Determination 2024/012

Regarding whether the installation of a woodburner complies with the Building Code

39 Marlborough Crescent, Richmond

Figure 1: The woodburner and hearth

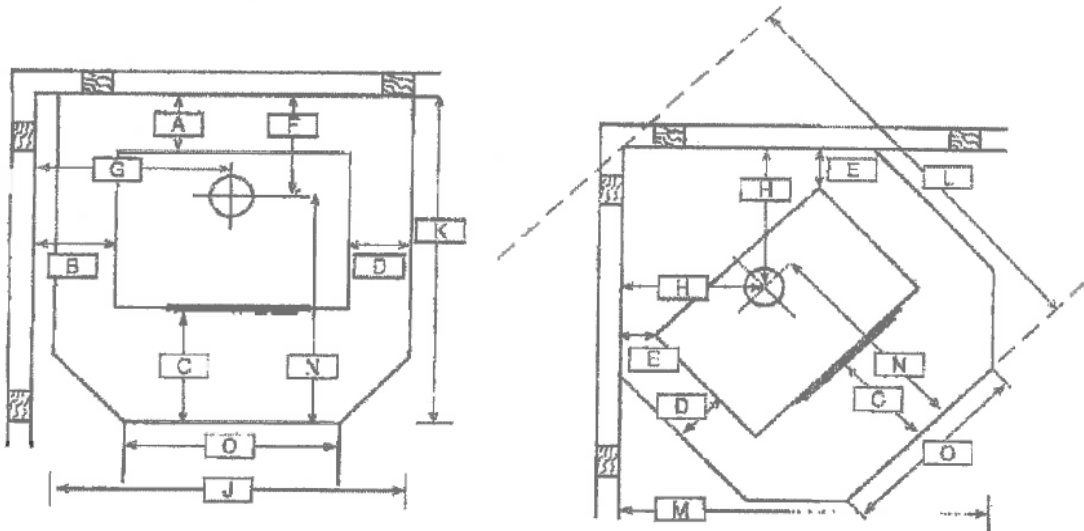
- 1.3.2. the front hearth clearance from the wood burner to a combustible surface (in this case, a timber floor) was 330mm, despite the manufacturer’s specifications requiring a clearance of 470mm.

- 3.4. With respect to the final inspection of the installation of the woodburner, the inspection report noted that:
- 3.4.1. “Fail - front hearth clearance from the drawer model is 470mm to a combustibles surfaces, actual clearance is approx..330mm, please amend to comply to manufactures requirements”; and

- 4.3.5. The authority is of the view that the as-built hearth is 140mm narrower than that required by the manufacturer's specification.
- 4.3.6. The authority submitted that as the hearth is not the "required length" as referred in the manufacturer's specifications, the hearth/floor protector is therefore not "protecting the combustible floor in front of it".

5.13. In this case the owners' hearth only extends 330mm beyond the woodburner. Therefore, the building work does not comply with AS/NZS 2918:2001 and therefore does not comply by way of C/AS1.

5.20. Due to the proximity of the front of the woodburner to the combustible floor materials (see also Figure 1), I consider this installation has the potential to increase the temperature of those materials beyond 90°C where the existing hearth ends.

5.21. Therefore, I find that the installation of the woodburner does not comply with clause C2.2 of the Building Code by way of alternative solution.

In accordance with section 188 of the Building Act 2004, I hereby determine that the installation of the woodburner does not comply with clause C2.2 of the Building Code.

Figure 3: Cross section of installation

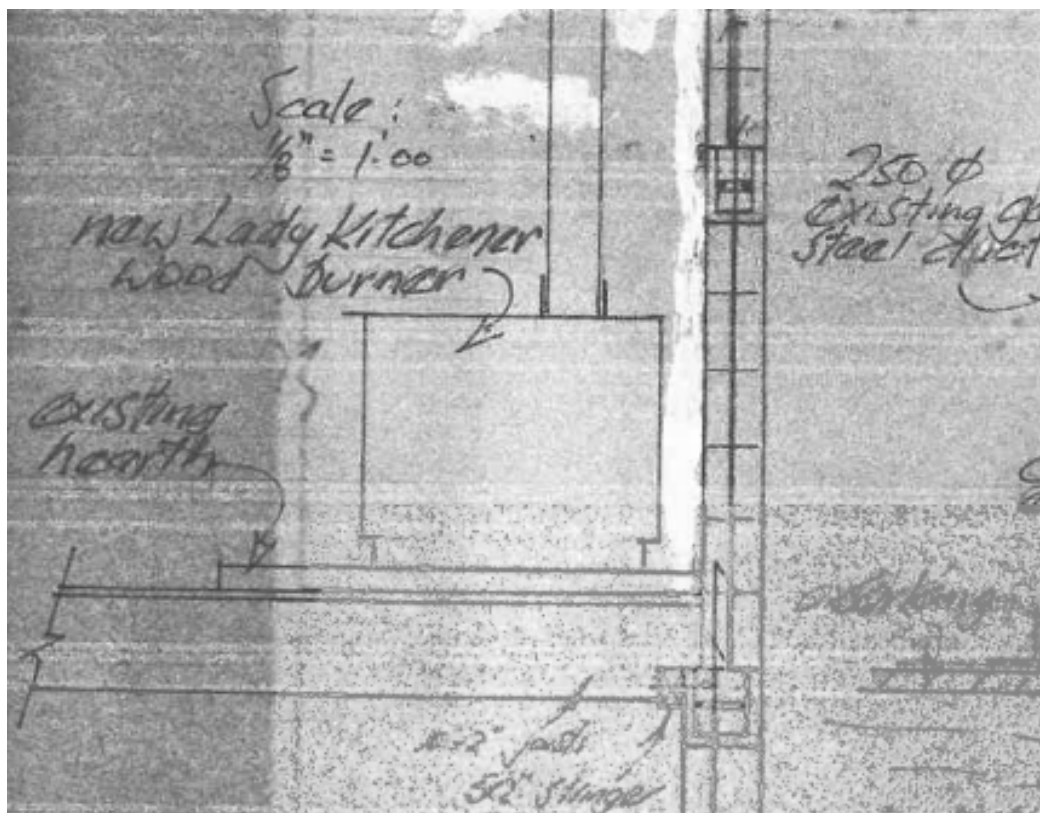
- 2.4. The authority approved documents for the woodburner included the installation and operation guide for the wood burner. The document included the clearance diagrams and tables provided above. All documents were stamped as approved documents by the authority and dated 2 September 2016. The documents also included a cross section showing the woodburner installed on the existing hearth but no dimensions were provided for the size or thickness of the existing hearth.

- 2.5. Based on the application it appears the approved plans for the building consent, which was granted by the authority, indicated that the woodburner was to be placed and installed on an existing hearth on the basis that the front and side dimensions of the hearth would comply with the manufacturers' specifications.
- 2.6. I note that if the woodburner had been the model with legs, then it would have only required a 300mm forward projection of the hearth beyond the woodburner (distance C in the Figure 2).
